**United States Department of the Interior
NATIONAL PARK SERVICE**

Docket ID No. EPA-R09-OAR-2012-0021

**National Park Service Comments on Best Available Retrofit Technology
for Apache, Cholla, and Coronado Power Plants in Arizona
September 17, 2012**

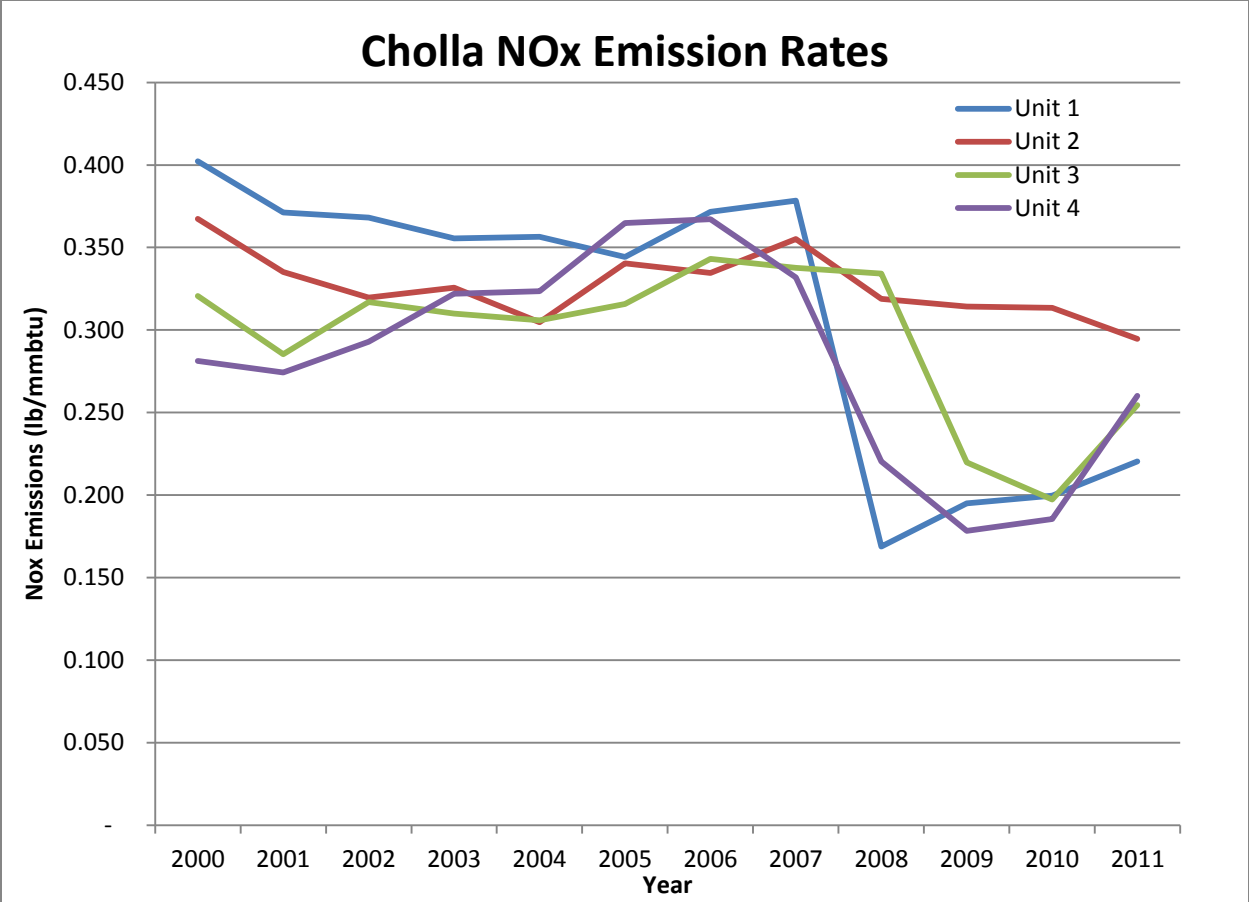
As noted above, we generally prefer to use the pre-control emissions. However, in this case, we agree with EPA R9's use of the most recent emissions as representative of future emissions with the new coal. The impact of the additional combustion controls and the new, higher-NO_x coal may be seen in the figure below.
